AP1000 GSI-191 Issue Resolution Recent Informal NRC Questions Presentation

AP1000 GSI-191 Issue Resolution Recent Informal NRC Questions

December 15, 2009

Dec 15, 2009 Meeting With NRC on Remaining Issues on AP1000 GSI-191

Debris Transport in HL LOCA

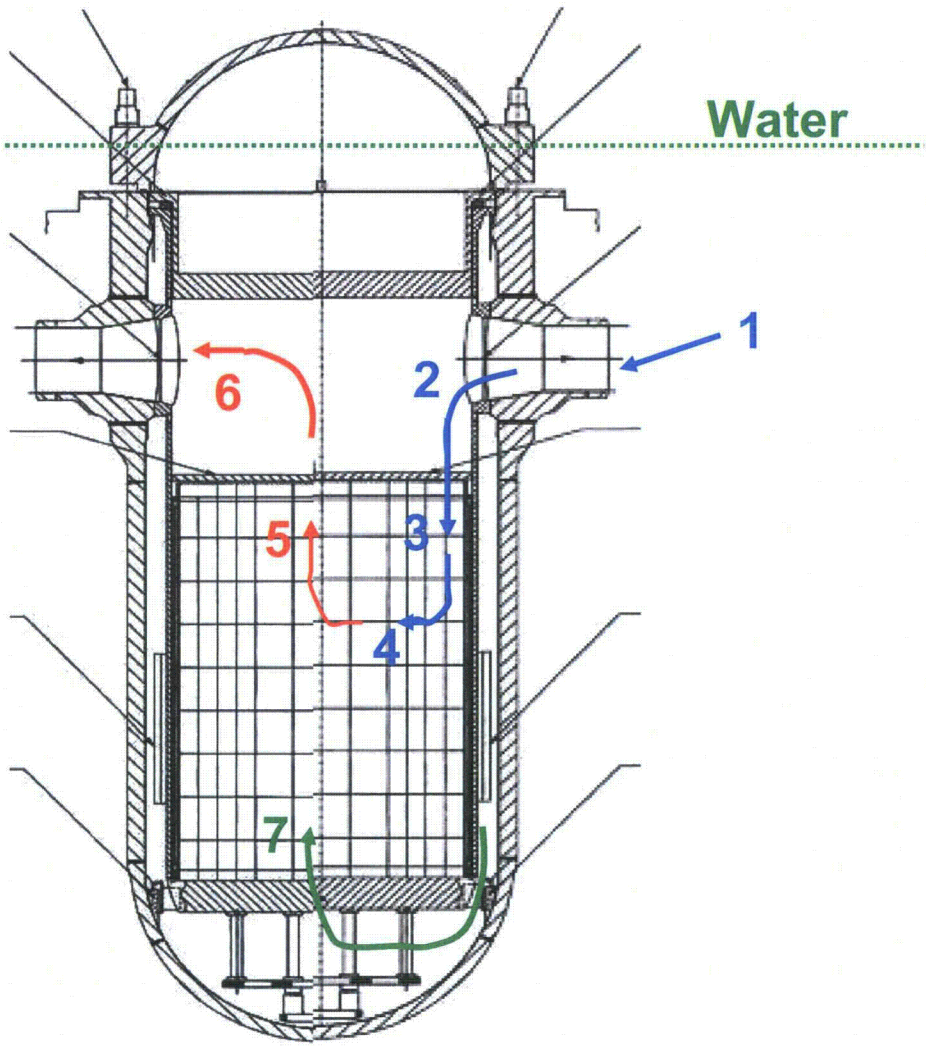
- NRC Question
  - The fuel assembly tests were performed with 1/3-length scale model with isothermal conditions. Provide justifications on how it can be scaled up to a full length with boiling in the upper portion of the fuel assembly.
- Response will be provided in 4 parts
  a. Use of 1/3-length FA
  b. Boiling impact on dP due to higher velocity
  c. Boiling impact on BA/TSP plateout
  d. Boiling impact on AlOOH dP characteristics

- Response
  - Boiling does not cause excessive dP
- Work
  - [ ] a,c
    - Debris can enter upper portion of fuel from HL and flow down through low power, periphery FAs, then cross over to high power central FAs (depicted in next slide)
    - [ ] a,c
    - [ ]
    - [ ]
- Schedule
  - To NRC 2/26/10 (RAI response and updated reports)

1. Water with debris could enter through HL break
2. Water / debris that is not carried directly out the ADS4 on the faulted HL can flow into RV
3. Water / debris entering RV can flow down in outer, low power, FA
   a. Some debris may be trapped as water flows down
4. Water / debris will cross over to central, higher power, FAs
5. Water / steam / debris will flow up through central FAs
   a. Some debris may be trapped as water/steam/debris flows up
6. Water / steam leaving core will flow out ADS stage 4 lines
7. Water with no fiber will be injected into downcomer from PXS and flow up through bottom of fuel assemblies
